# Office Action Summary

Application No.  
09/759,579

Applicant(s)  
ROBERT F. HEARD ET AL.

**DETAILED ACTION**

FIG 9

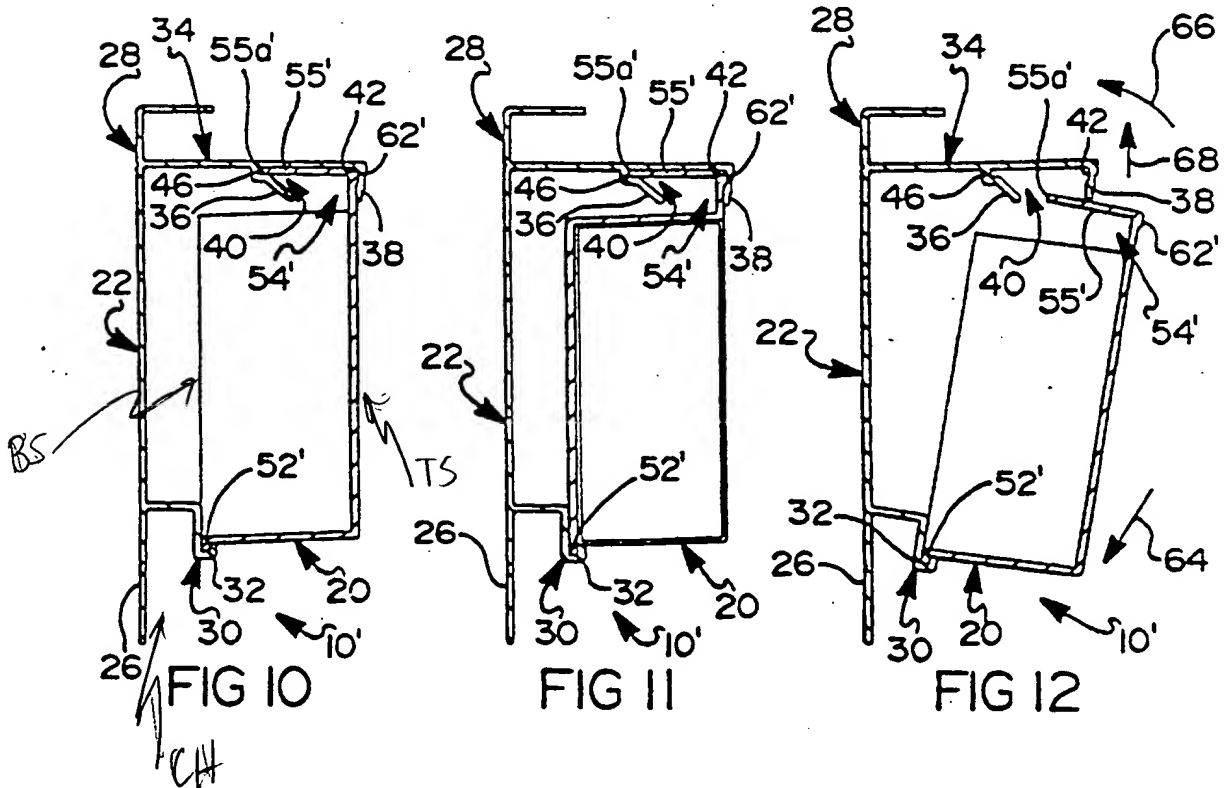
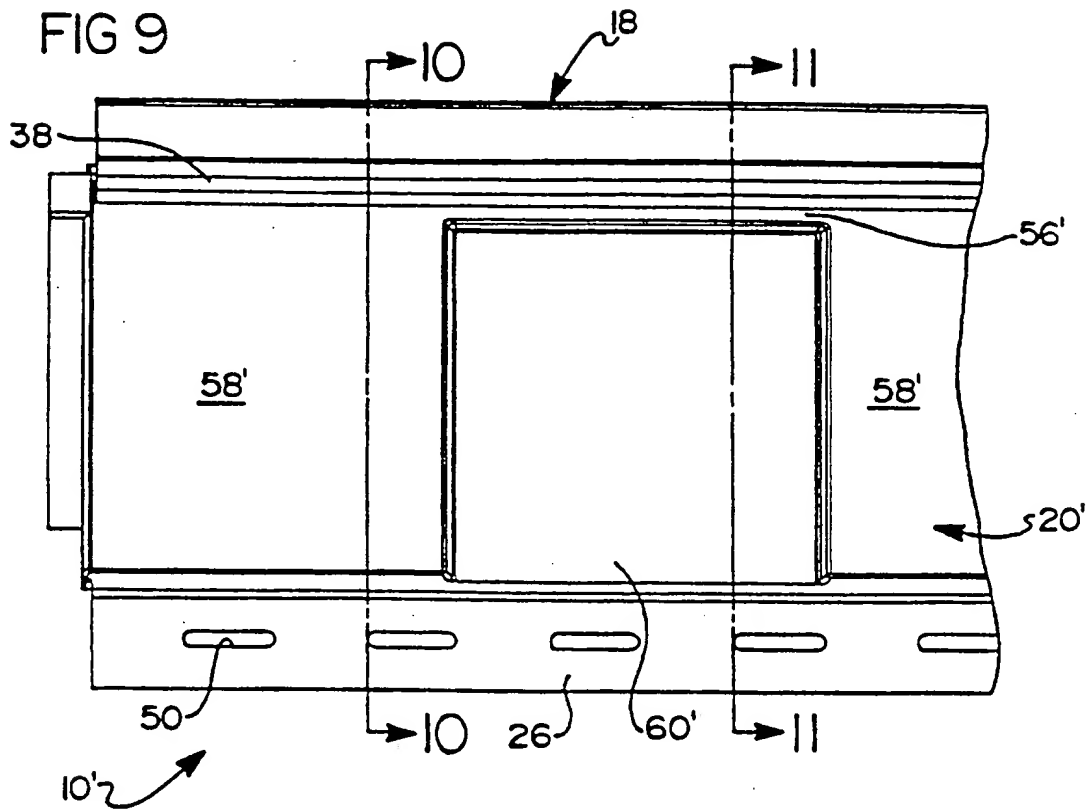
4. Claims 1,2,4,5 and 10 are rejected under 35 U.S.C. 102(b) as being anticipated by US Patent #5,850,717 to SCHIEDEGGER et al. SCHIEDEGGER et al. discloses the use of a brickmolding (10') including a rectangular portion (20, <sup>100</sup>~~106~~,200) having a bottom surface (BS), a top surface (TS), see the marked-up attachment, a flange portion (26) extending beyond the rectangular portion (20,106,200) in parallel relationship to the bottom surface (BS) and a channel

(CH), see also the marked-up attachment, for receiving a siding member (12) therein. Regarding claim 2, the top surface (TS) is and carries the decorative portion. In reference to claims 4,5 and 10, the flange (26) is formed integrally with the brickmolding (10) and has pre-formed openings (50) to receive a fastener, column 6, lines 3-6 such that the flange (26) is affixed to the building adjacent the bottom surface (BS). Claims 1,2,11-13,15,16 and 19 are rejected under 35 U.S.C. 102(b) as being anticipated by US Patent #5,090,174 to FRAGALE. Regarding claims 1 and 12, FRAGALE discloses the use of a brickmolding (10) affixed to a fenestration (F), column 4, line 25, for receiving a siding (30) wherein the brickmolding (10) includes a rectangular portion formed by (~~12,16,18~~ and 104) having a bottom surface (BS), see the marked-up attachment, a top surface (130), a flange portion (114) extending beyond the rectangular portion formed by (~~12,16,18~~ and 104) in parallel relationship to the bottom surface (BS) and a channel (128) for receiving the siding member (30) therein. Regarding claims 2 and 13, the top surface (130) is and carries the decorative wood exterior, column 5, line 14 and column 7, lines 29 and 30. In reference to claims 11 and 19, the brickmolding (10) is comprised of a polyvinyl chloride material, (column 3, line 53 and column 5, line 15), and includes a foam insulating material (104). Regarding claims 15 and 16, the flange (114) is formed integrally with the brickmolding (10) such that the flange (114) is affixed to the building adjacent the bottom surface (BS) by a fastener (column 6, line 51).
